To: Jack Varozza, City of Roseville

From: Raina Joby and John Gard, Fehr & Peers

Subject: Evaluation of Access and On-Site Circulation for the Proposed Hayden Commercial Center

The study evaluates site access and on-site circulation elements against requirements prescribed in the *City of Roseville Design Standards* (City of Roseville, 2025) based on the latest project site plan (*Hayden CSP- Concept 10, Milestone Imagineering, Inc., Sep 24, 2025*).

FIGURE 4

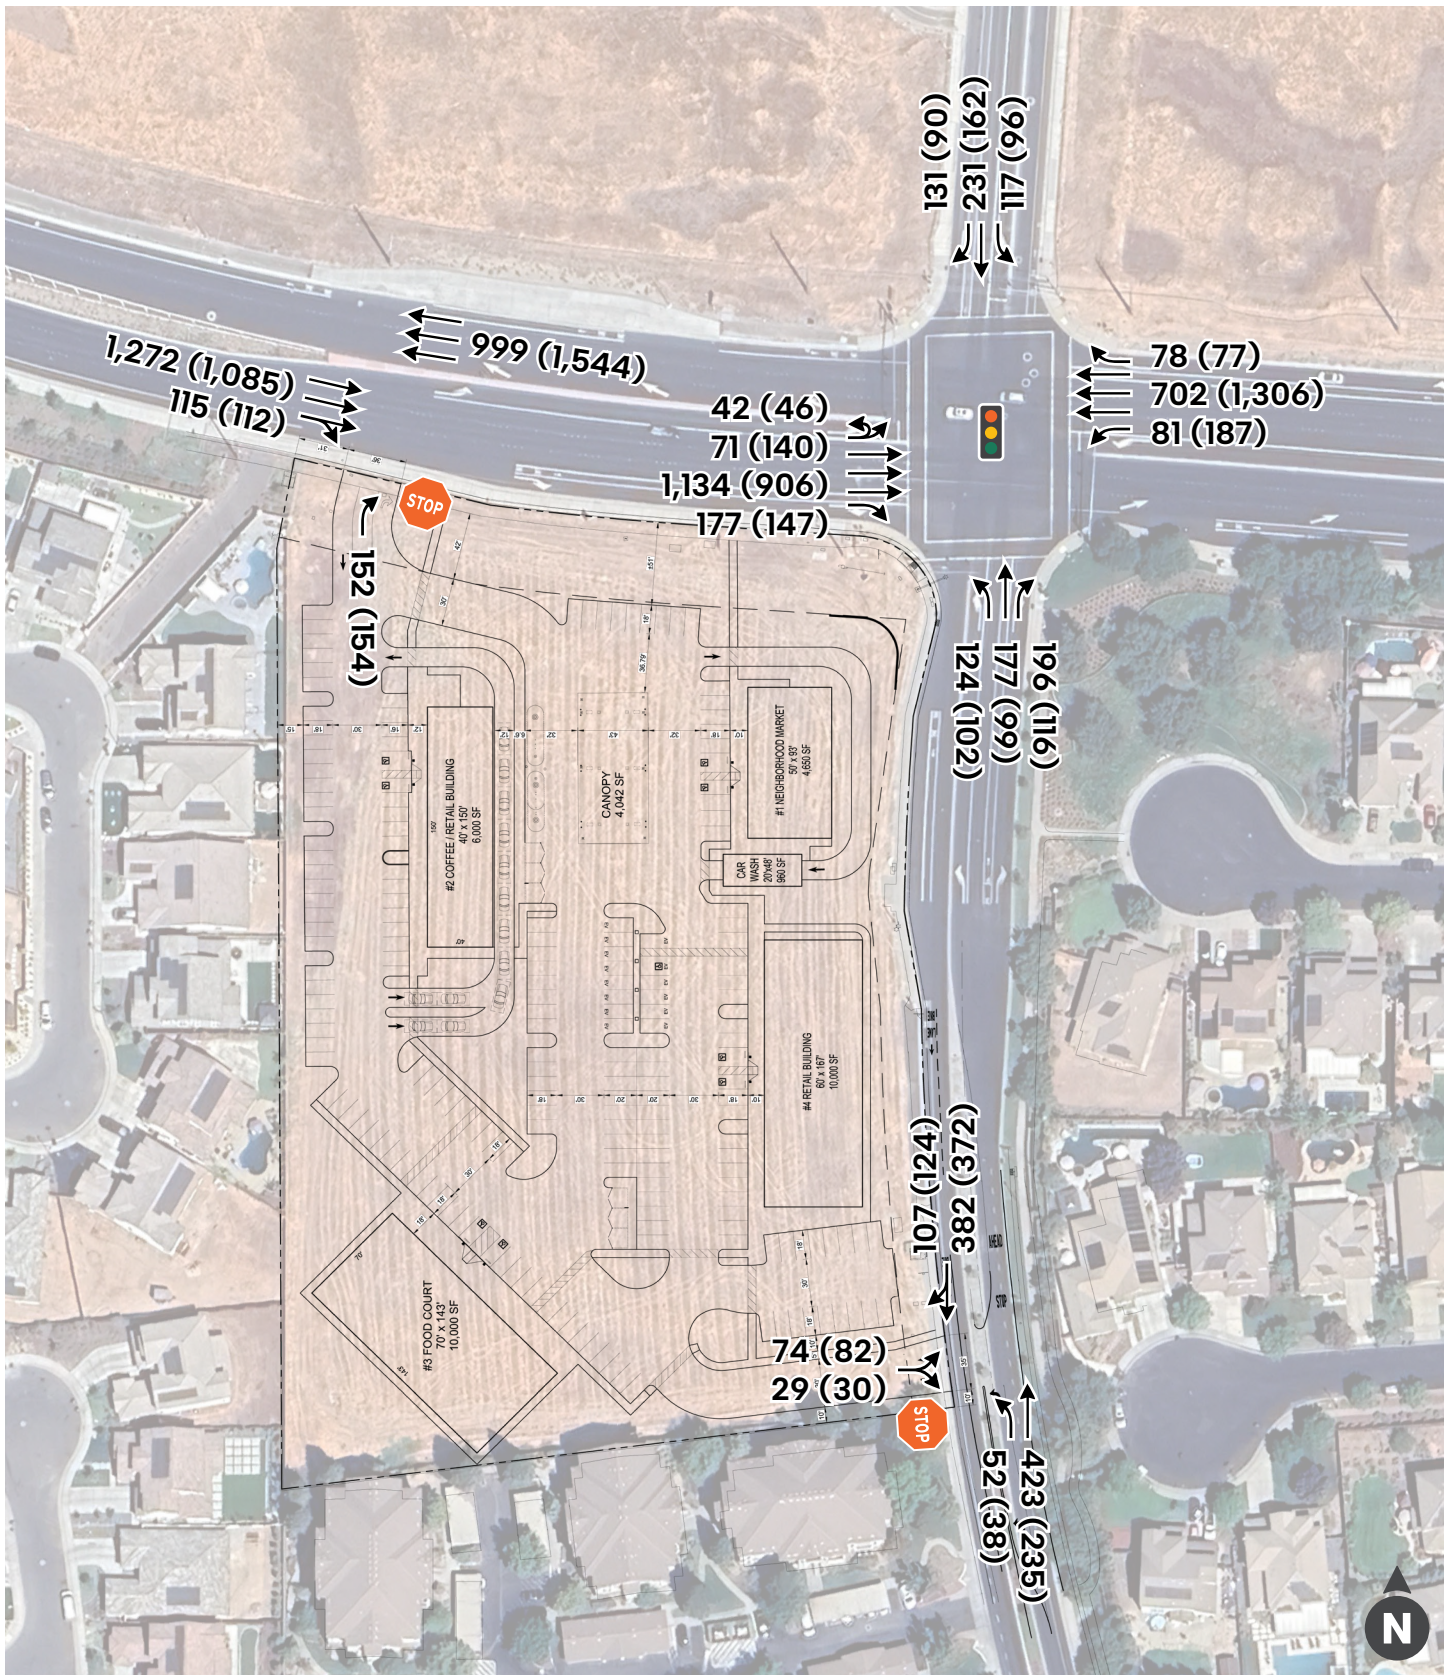
It is apparent from Figure 4 that approximately 75 vehicles during the PM peak hour would depart Driveway 2, weave across three lanes of Blue Oaks Boulevard and access the left/u-turn at the signalized intersection at Hayden Parkway. Motorists would have about 300 feet in which to perform this maneuver, which will be complicated by the heavy volume and high speeds of traffic on eastbound Blue Oaks Boulevard. Gaps in traffic will be created when a traffic signal is eventually installed at the Blue Oaks Boulevard/Westpark Drive intersection (situated about one-half mile to the west).

Figure 5 (a)

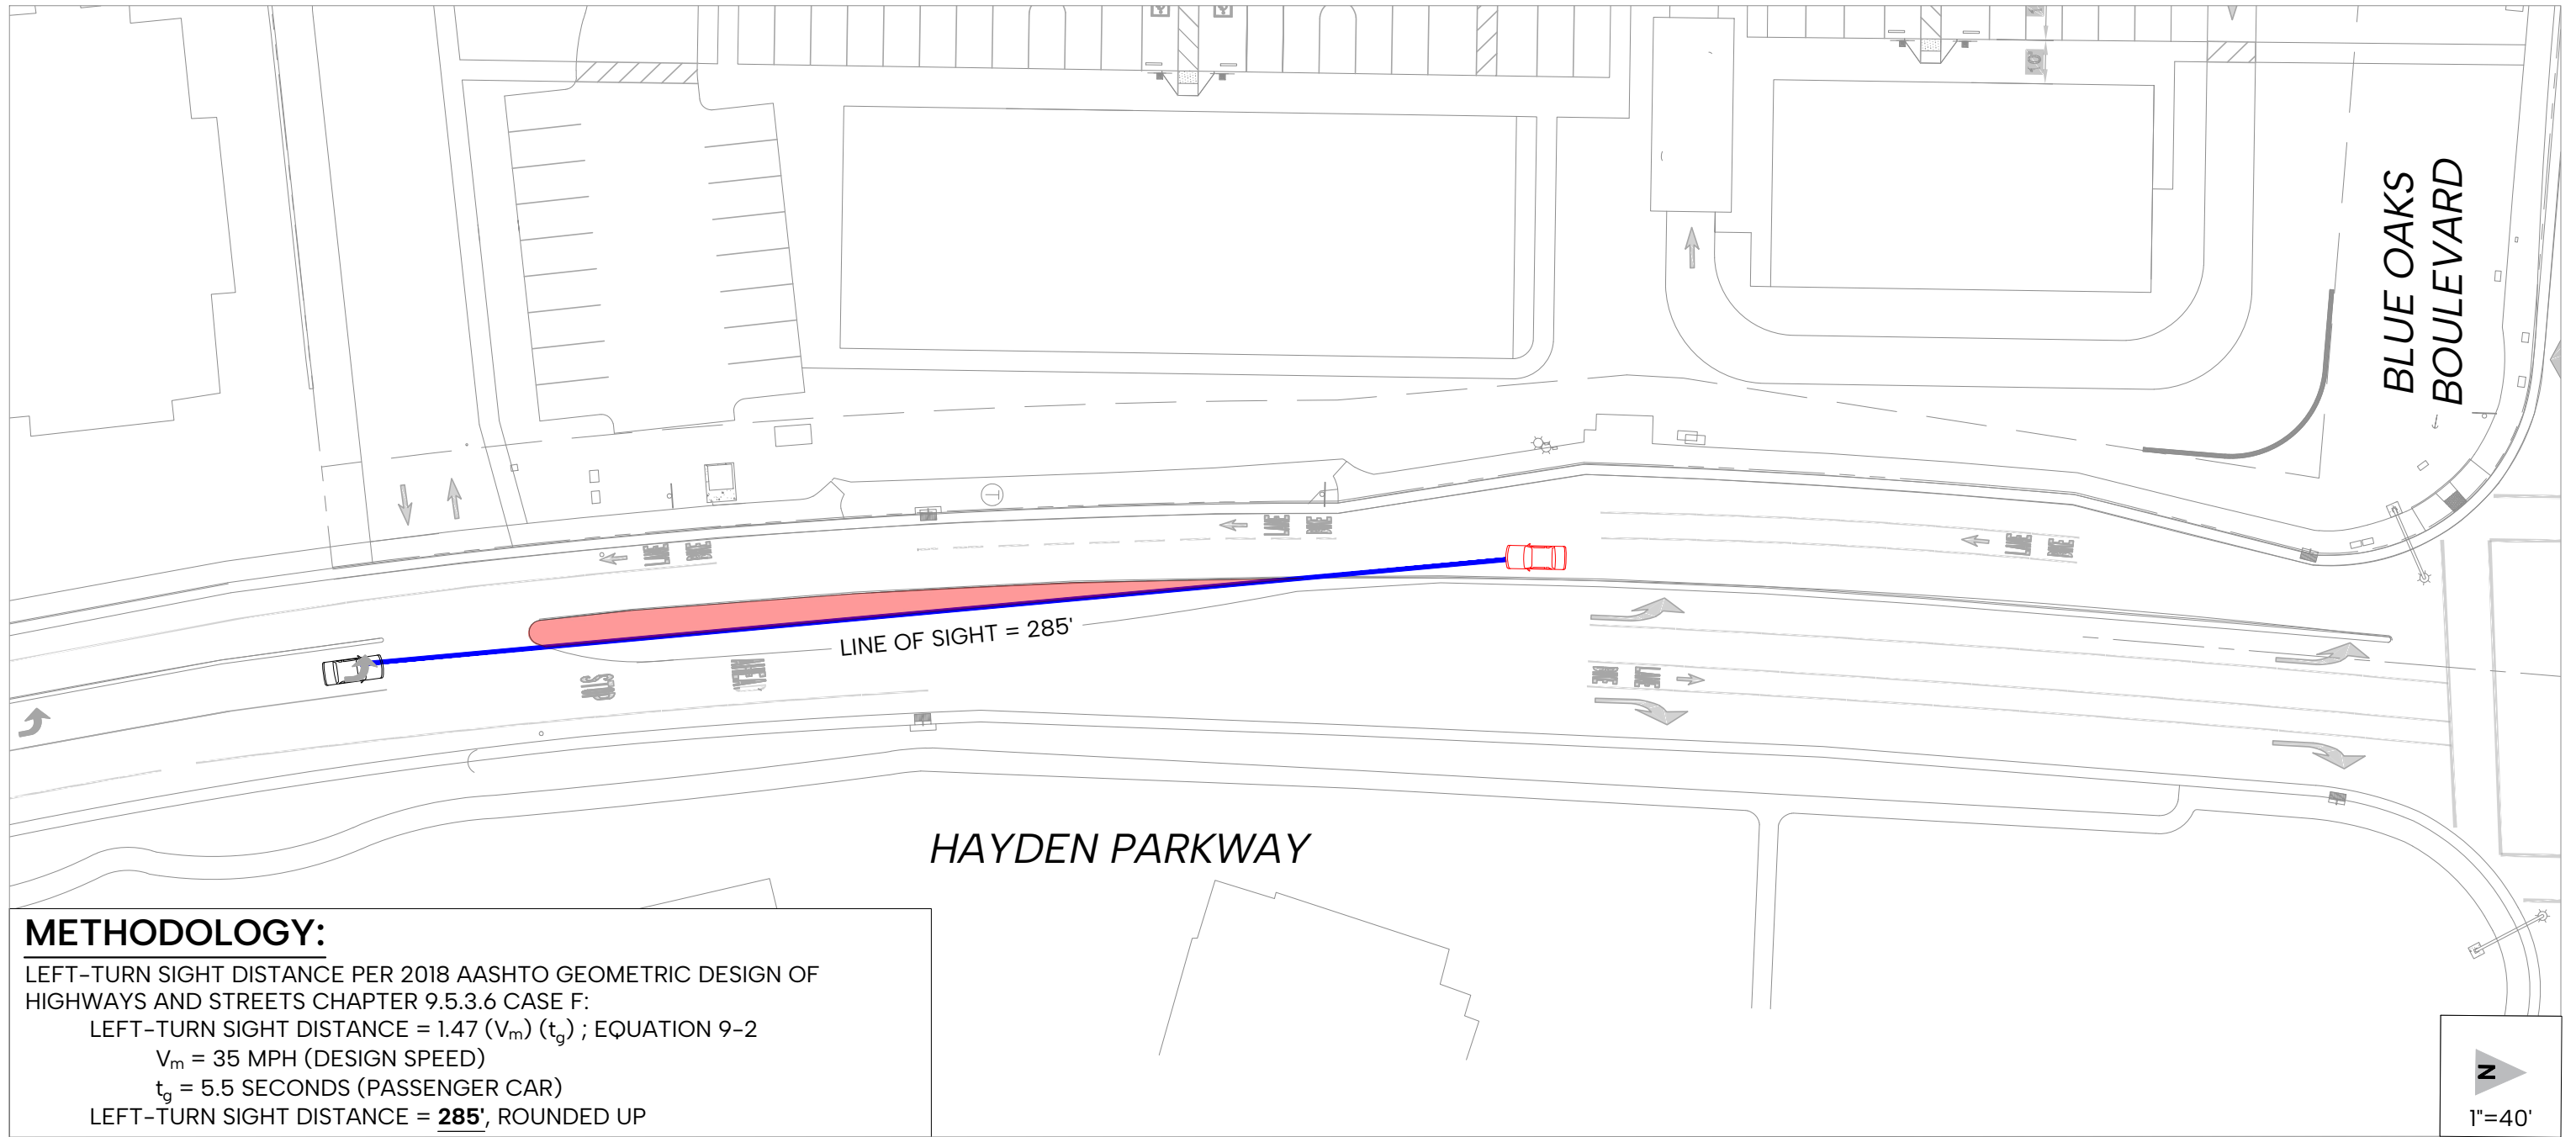
Figure 5a illustrates left-turn sight distance required for motorists on northbound Hayden Parkway waiting to turn left into Driveway 1. These calculations are based on the methodology recommended in chapter 9 of the *AASHTO Geometric Design of Highways and Streets* (American Association of State Highways and Transportation Officials, 2018). Note that a design speed of 35 mph was applied for this analysis based on an April 2025 off-peak speed survey of this segment, which showed its 85th percentile vehicle speed was 35 mph. Key findings from this figure are:

- The line of sight for motorists performing this left-turn does not overlap with the northbound left turn pocket at the Blue Oaks Boulevard/Hayden parkway intersection. This confirms that left turn queuing at this intersection will not obstruct the line of sight.
- The line of sight will pass through the landscaped median area immediately north of the left-turn pocket, which leads to Recommendation #1 below.

Recommendation 1: Limit any vertical elements in shaded area of Figure 5a to either 0.5-foot high or less landscaping or hardscaping to ensure an adequate line of sight for motorists turning left into Driveway 1.

Figure 5 (b)
SIGHT DISTANCES TURNING OUT OF HAYDEN PARKWAY DRIVEWAY
BLUE OAKS BOULEVARD AND HAYDEN PARKWAY
ROSEVILLE, CA

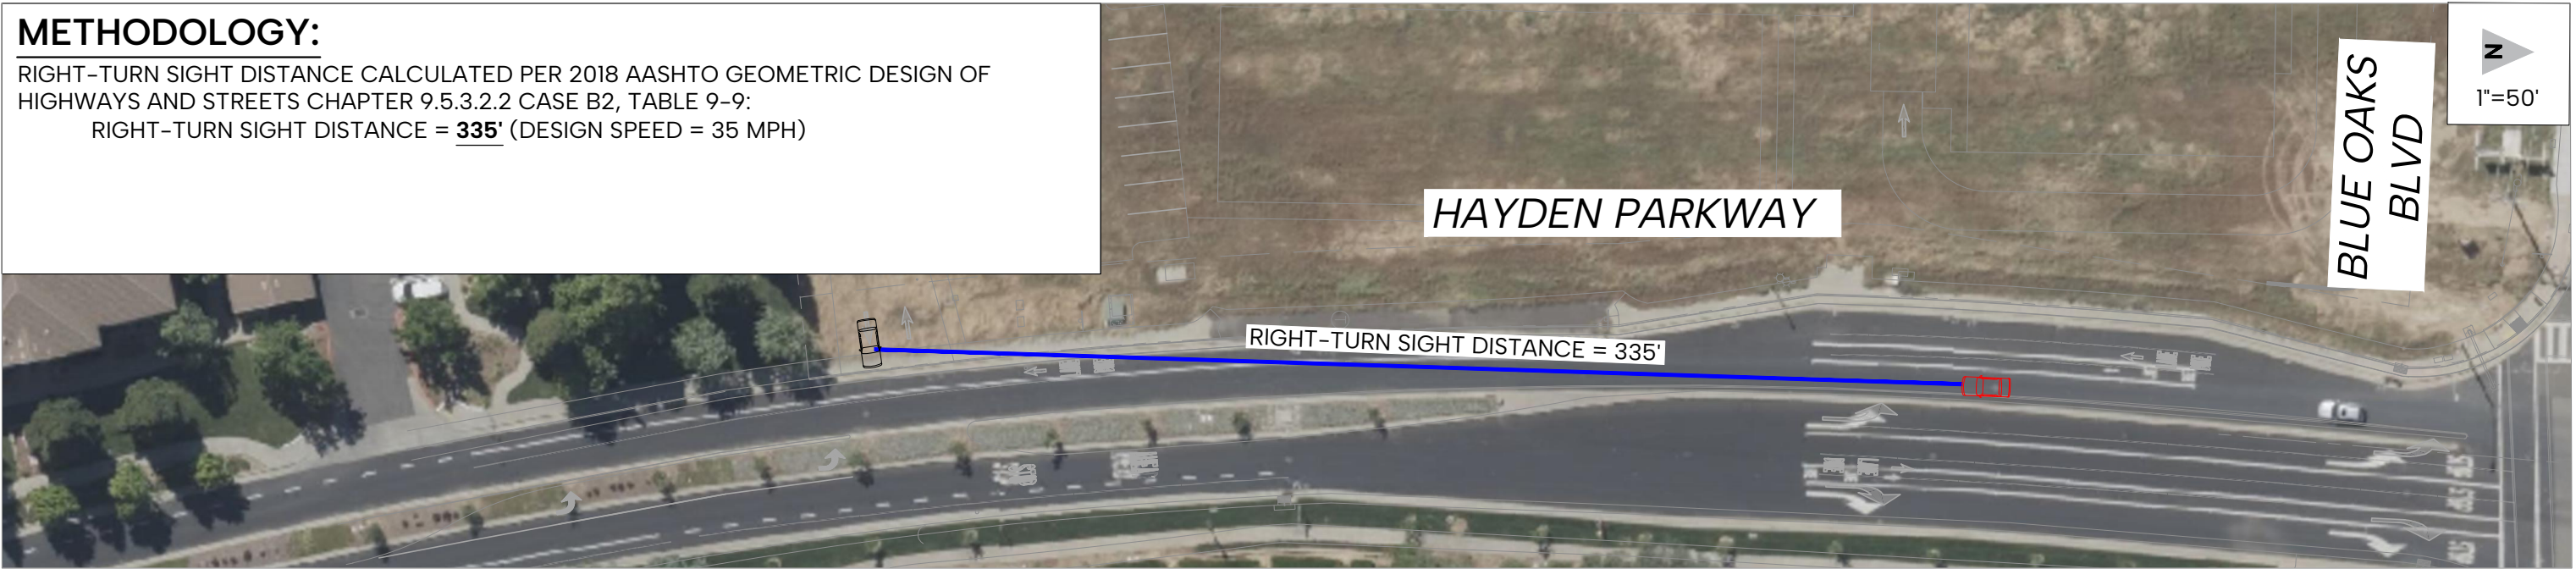
Figure 5b illustrates the sight distance available for a motorist about to exit Driveway 1 onto Hayden Parkway while looking to the left and right. As shown, adequate sight distance is available in each direction. As is described later, the majority of the landscaped median south of Driveway 1 would be removed to provide for the left-turn pocket and bay taper, meaning existing trees and shrubs that could otherwise block the line of sight will not be present.

Image 5: Project site plan showing striping at Driveway 2

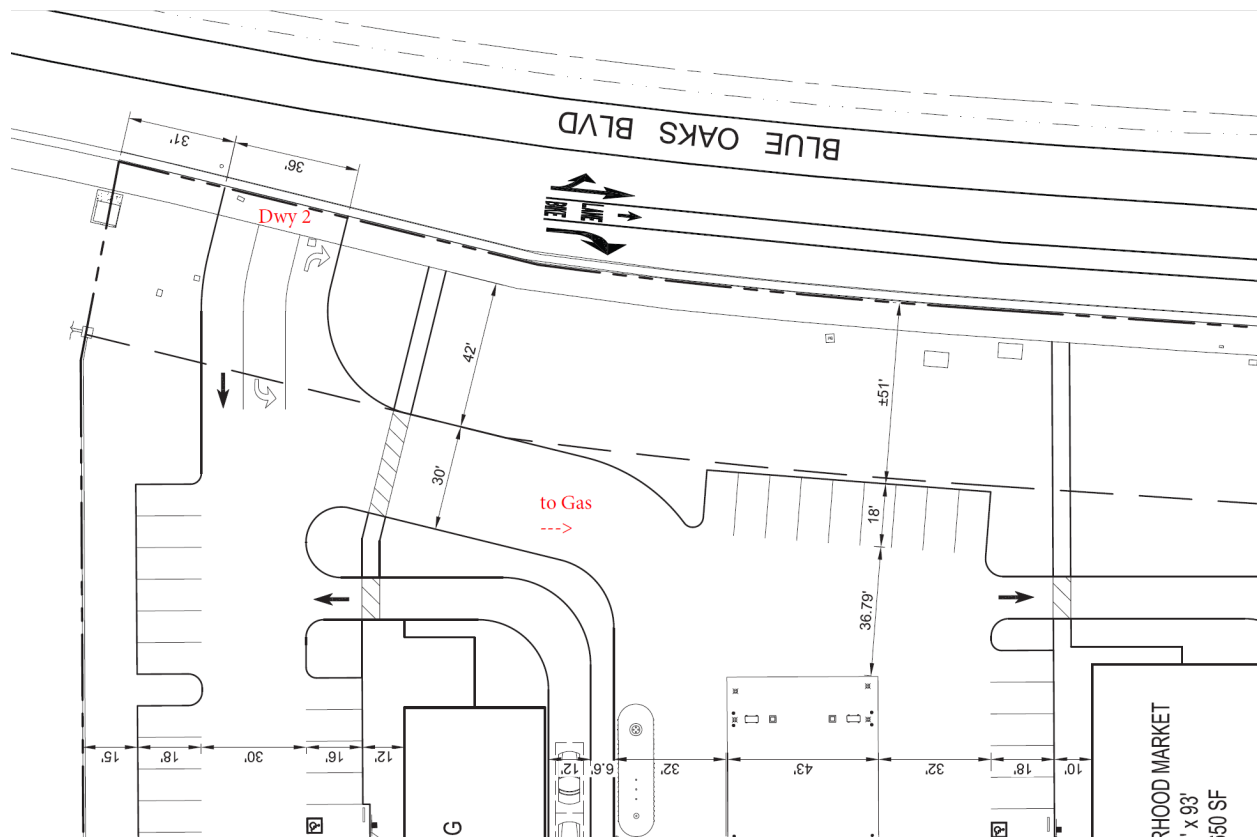
As shown in Table 3, the available storage at Driveway 1 is more than adequate to accommodate the maximum expected queue of three vehicles. However, the maximum queue at Driveway 1 would exceed the available storage. However, the site plan incorporates an innovative lane striping treatment to accommodate this peak queuing condition.

As shown in **Image 5**, the ingress would be striped with a through lane and a left-turn lane (that would provide access to gas station). Should outbound traffic block entry to the gas station drive aisle, motorists desiring to enter that area could wait in the left-turn lane. This design is in place at a gas station / retail center in the southeast corner of the Pleasant Grove Boulevard/Fairway Drive intersection and has shown to function well. This is a more desirable treatment than the alternative concept of adding “Keep Intersection Clear” signing and striping (which motorists do not always follow).

- A row of 18 parking spaces adjacent to the coffee shop/retail building are 16 feet deep. They might cause parked vehicles to partly obstruct the driving aisle.
- The northbound drive aisle approaching Driveway 2 (just beyond coffee shop drive-through lane exit) is not aligned with the driveway exit lane (see Image 5).

Recommendation 5: Slightly alter the layout of the first intersection south of Driveway 2 to reduce the northbound travel offset.
